PROPOSED MODIFICATION

SAFETY RELATED DIVISION 1		WASHINGTON PUBLIC POWER SUPPLY SYSTEM RICHLAND, WASHINGTON 99352-0568		WNP 2	
SIGNED	DATE	TITLE			
APPROVED	W. HOLLE	ELECTRICAL WIRING DIAGRAM			
ENGINEER	W. HOLLE	RESIDUAL HEAT REMOVAL SYSTEM			
DESIGN SUPV	EBF	MOV RHR-V-B (E12-F00B)			
CHECKED	FRAN	DRAWING # EWD-9E-024			
DRAWN	D. JACOBSEN	SCALE N/A REV. 6 SHEET OF

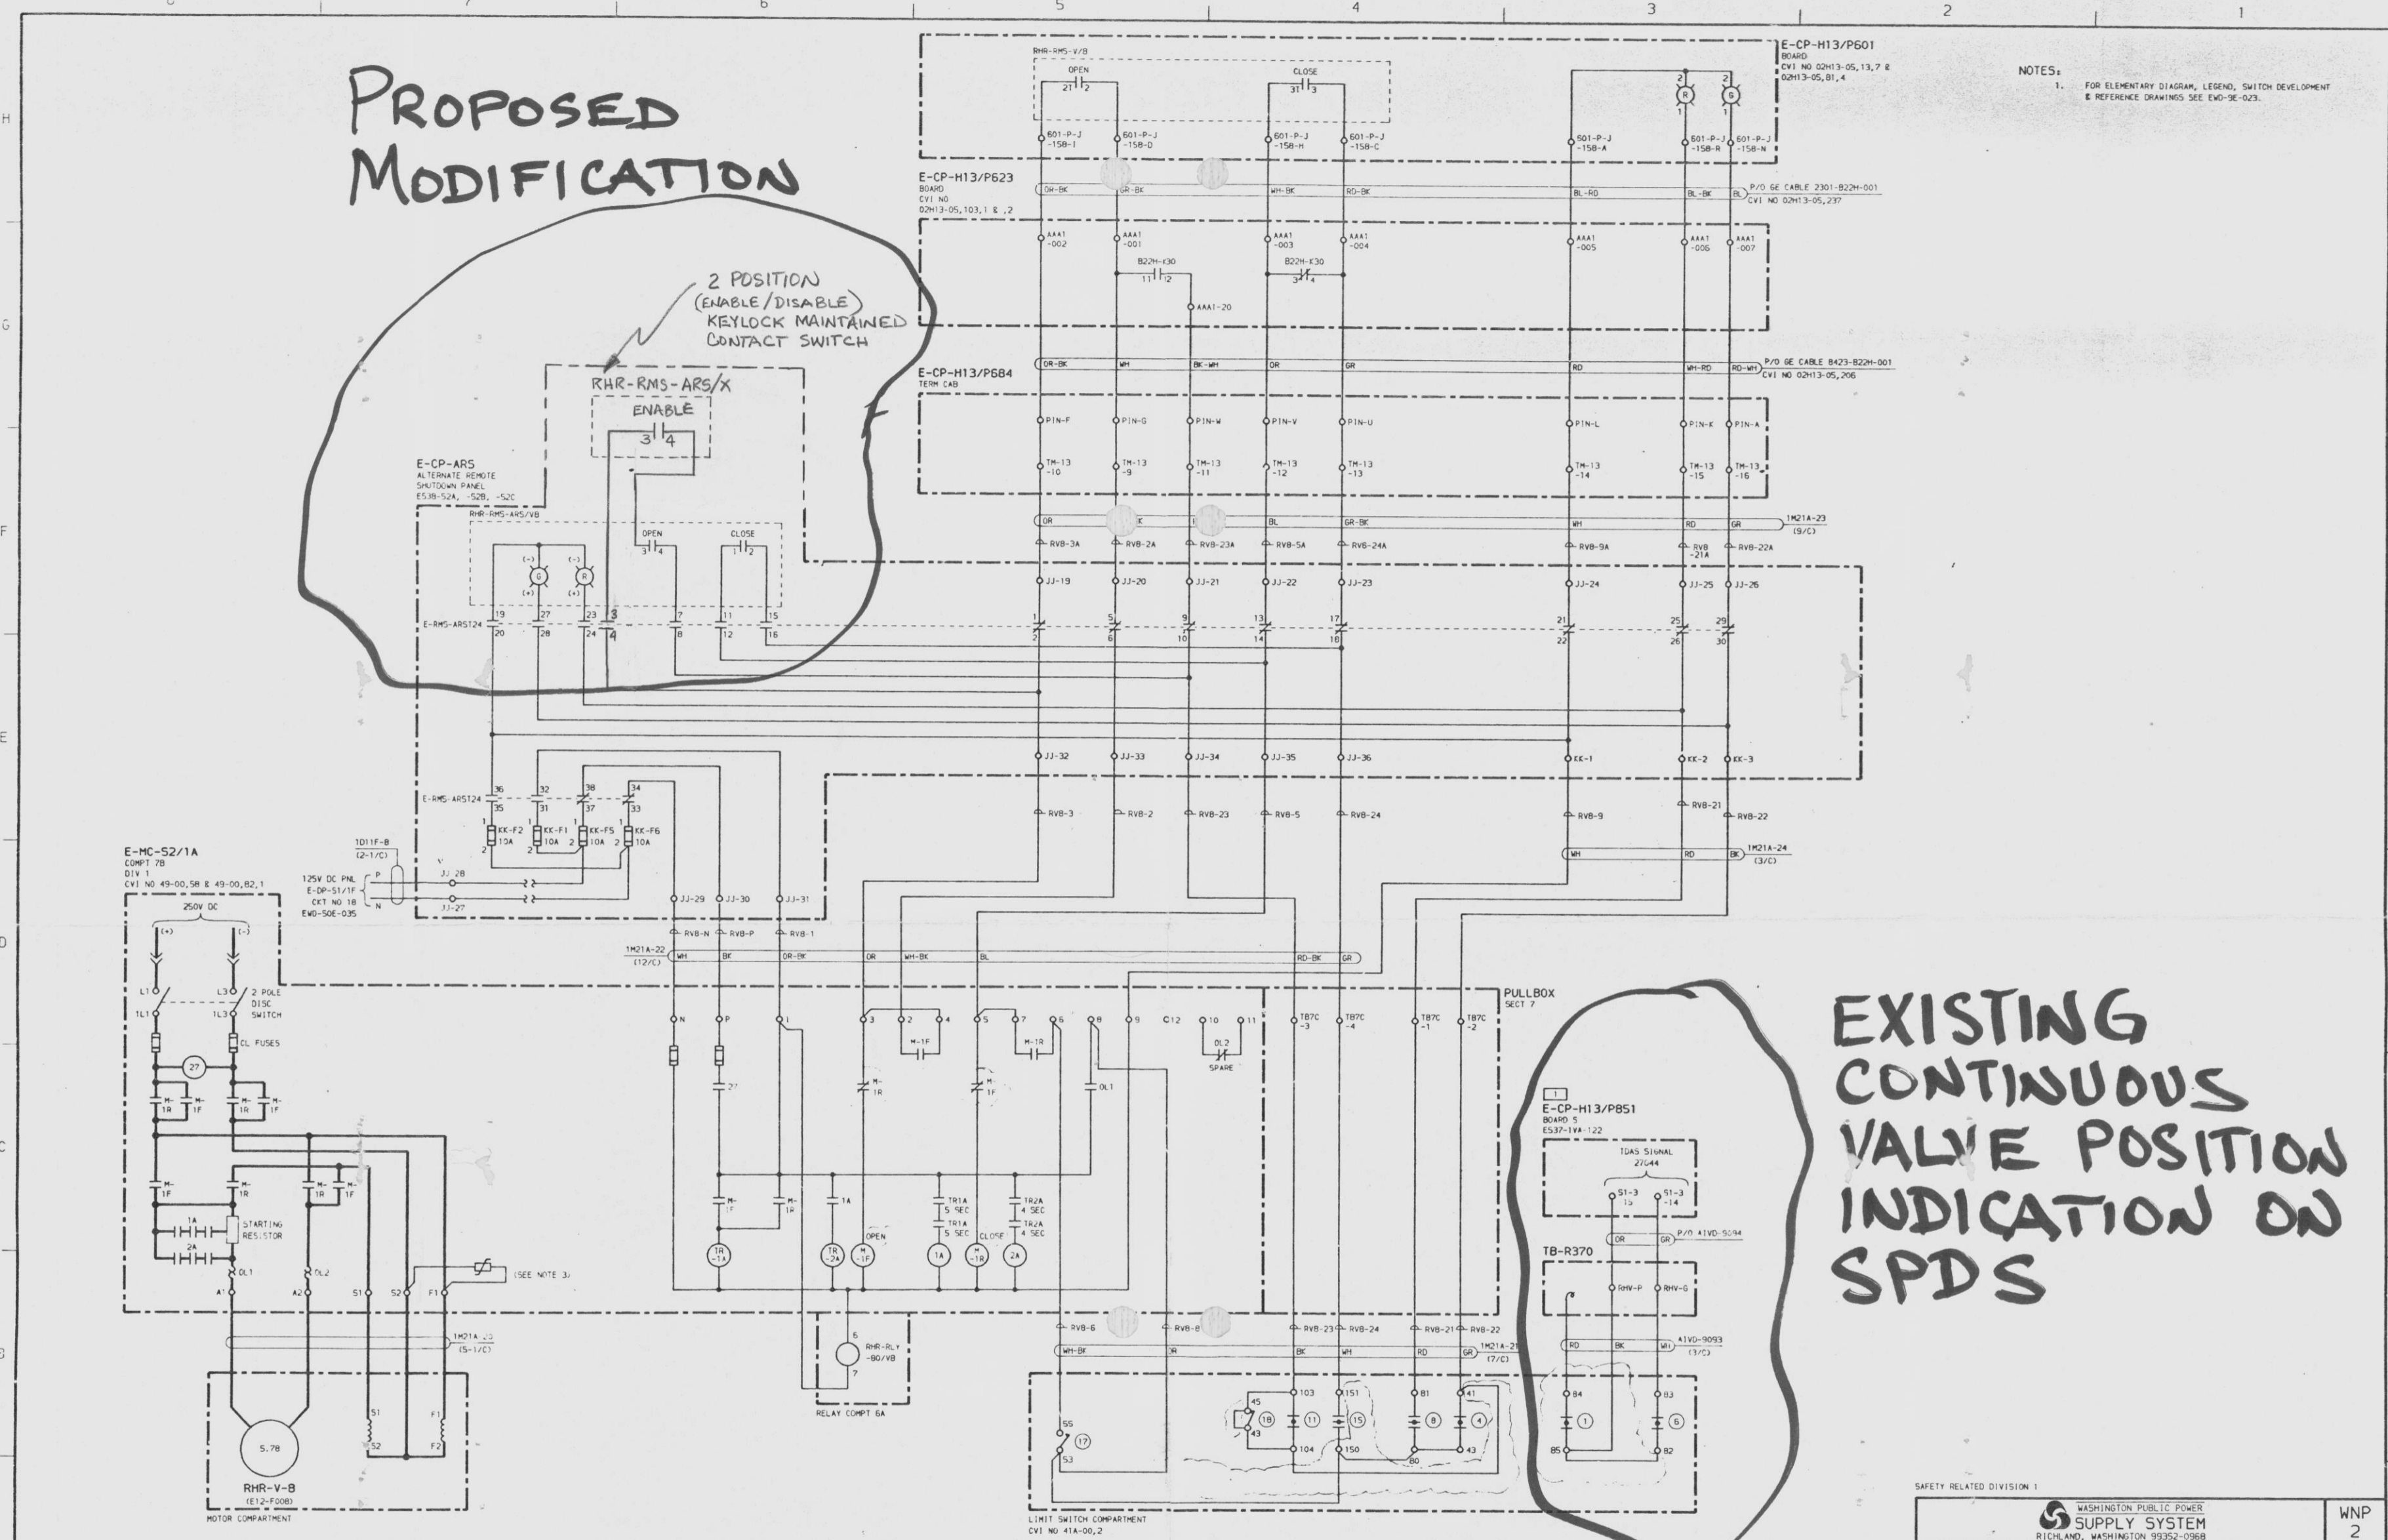
2 POSITION
(ENABLE/DISABLE)
KEYLOCK MAINTAINED
CONTACT SWITCH

EXISTING
CONTINUOUS
VALVE POSITION
INDICATION ON
SPDS
